# UNITED STATES DEPARTMENT OF COMMERCE United States Patent and Trademark Office

APPLICATION NO.	FILING DATE	FIRST NAMED INVENTOR			ATTORNEY DOCKET NO.
09/764,473	01/17/01	ROCHELEAU		J	1296-015
PM82/0529 LAWSON, PHILPOT & PERSSON, P.C. 67 WATER STREET, SUITE 110				EXAMINER DUNWOODY, A	
				ART UNIT	PAPER NUMBER
LACONIA NH	)3246			3629	9
				DATE MAILED:	05/29/01

### **DETAILED ACTION**

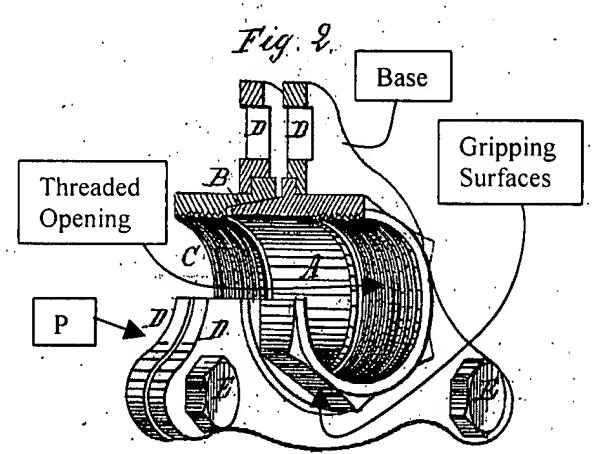
Claims 1-3 are rejected under 35 U.S.C. 102(b) as being anticipated by US patent 19818, Shaw. In figure 2 below, Shaw discloses a threaded pipe flange (P)

comprising a base portion

having a

predetermined shape and at least two openings (D) dimensioned to accept at least two mounting bolts; a shoulder portion (A) extending from and integral to the base portion, and the shoulder portion having two to six substantially flat gripping surfaces; at least two mounting bolts (E); and a threaded opening extending through the base and shoulder portion, and dimensioned for attachment to a predetermined threaded pipe.

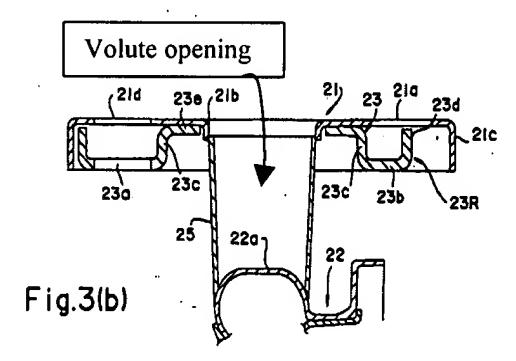
Claims 8 and 12 are rejected under 35 U.S.C. 103(a) as being unpatentable over US patent 5133642, Kajiwara, in view of Shaw. Kajiwara discloses on a pump (not shown, but "FIG. 4 is a sectional view...of a pipe joint at the discharge side of a pump"; column 3, lines 45-47); and in figure 3b below, one volute flange (21)

comprising a volute opening, and at least two

bolt openings (21a, 21b). Shaw discloses a pipe joint as discussed above in regards to claims 1-3 having the aforementioned features; "the two nuts [Shaw, reference number A] are screwed or otherwise secured onto the ends of the [threaded and not shown] pipes to be joined" (Shaw, column 1, lines 23-25). It is well known in the art to use volute flanges of the type taught by Kajiwara, and pipe joints of the type taught by Shaw to form a piping system. It would be obvious to a person of ordinary skill in the art at the time the invention was made to use Kauiwara's volute flange and Shaw's pipe joint to form a piping assembly.

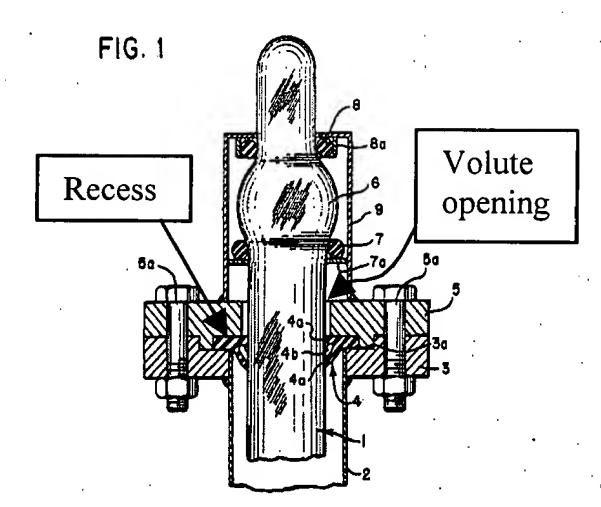
Claims 9-11 are rejected under 35 U.S.C. 103(a) as being unpatentable over Kajiwara in view of Shaw as applied to claims 8 and 12 above, and further in view of US patent 3998477, Delahaye. Kajiwara in view of Shaw fails to disclose a gasket disposed between the pipe flange and the volute flange, and a volute flange with a flat surface having a recessed portion surrounding the volute opening. In figure 1 below, Delahaye

discloses a

gasket (4), volute flange (5),

and a flat surface (3a) having a recessed portion surrounding the volute opening to provide a "leak proof" (Delahaye, column 2, lines 17-18) connection. It would be obvious to a person of ordinary skill in the art at the time the invention was made to provide a gasket and a volute flange with a flat surface having a recessed portion surrounding the volute opening to ensure a leak proof connection.
